## RFP - ADDENDUM

### Ridgewater Hutchinson East Camus Roof Replacement

August 7, 2018

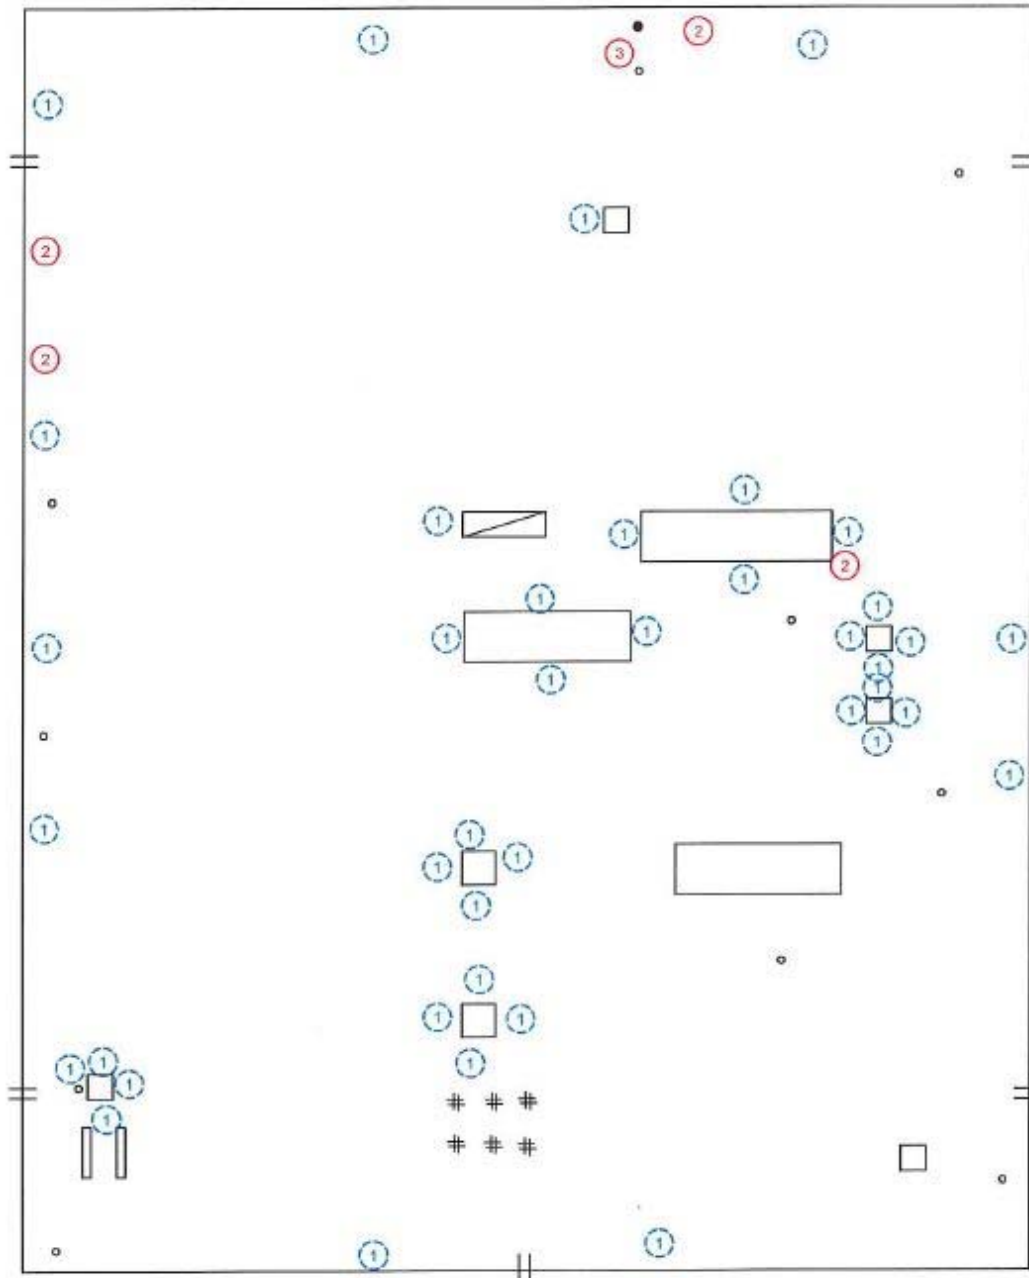
4. Questions regarding removing obsolete mechanical and electrical equipment?  
*See the attached roof study from the Owner's "Roof Pro" database showing equipment on the roof. Highlighted equipment will be removed as part of this project.*
